From: Kubeczko, Dave
Sent: Monday, November 30, 2009 12:35 PM
To: Kubeczko, Dave
Subject: FW: K P Kauffman Company State 3-14, NENW Sec 14 T4S R62W, Arapahoe County, Form 2A #1692867 Review

Scan No. 2032664 CORRESPONDENCE Form 2A#1692867

I have been reviewing the K P Kauffman State 3-14 **Form 2A** (#1692867). COGCC requests the following clarifications regarding the data K P Kauffman has submitted on or attached to the Form 2A prior to passing the Oil and Gas Location Assessment.

State #3-14 well location

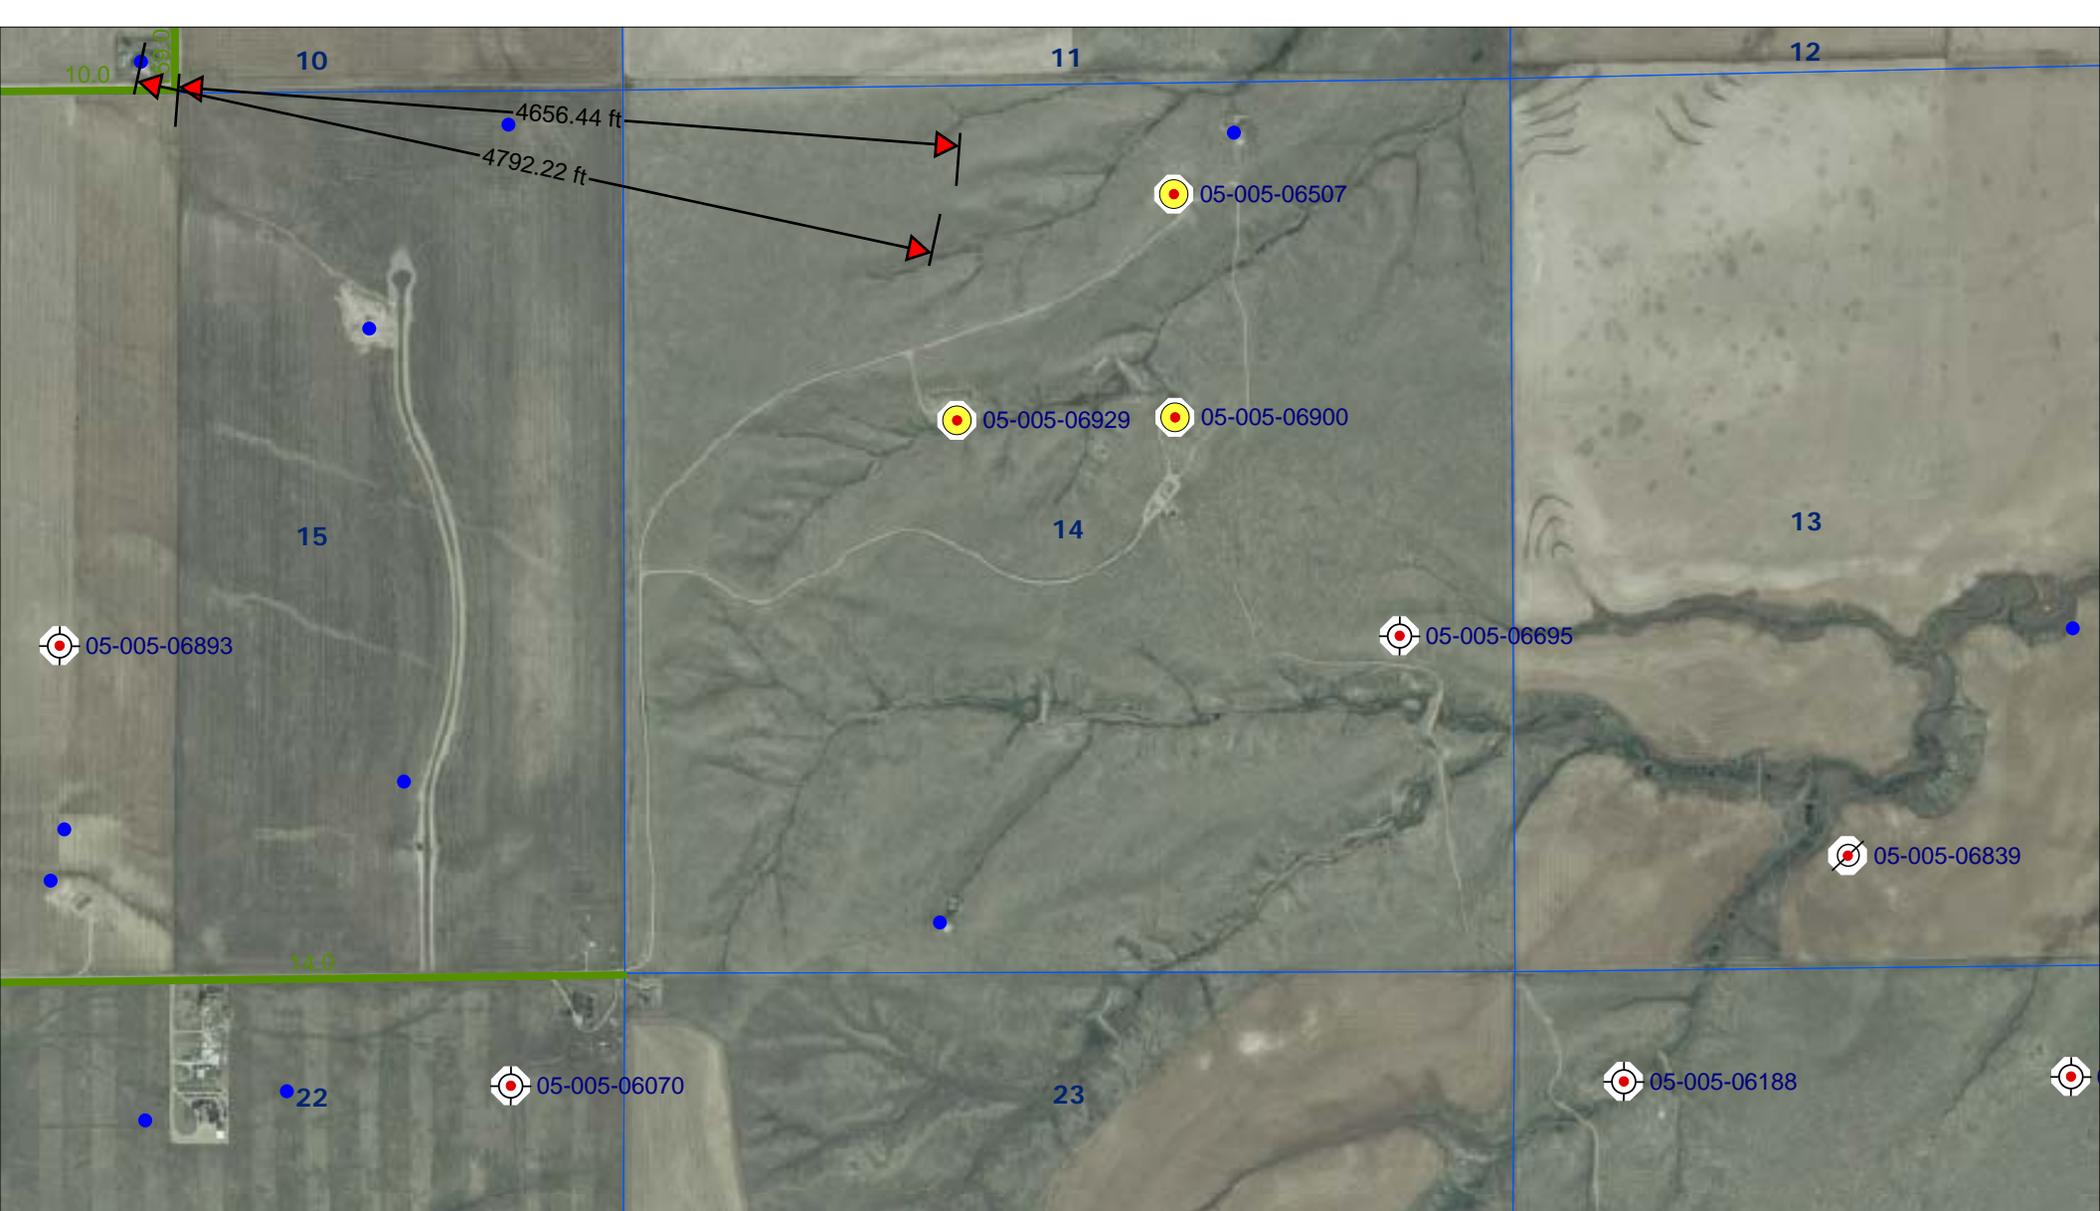
1. **Cultural (Section 9):** The Form 2A indicates distances to nearest building of 5280 feet and the nearest above ground utility of 5280 feet. During COGCC's review of the 2005 aerial photograph, the distance to the nearest building was 3578 feet, but I couldn't verify the distance to the nearest above ground utility. Could you let me know where and how the nearest above ground utility was located. I can make the changes if you send an email with this request.

The nearest building distance is actually 4792' (to northwest, just NW of water well) and nearest road is 4656' to northwest (power lines along road). Thanks.
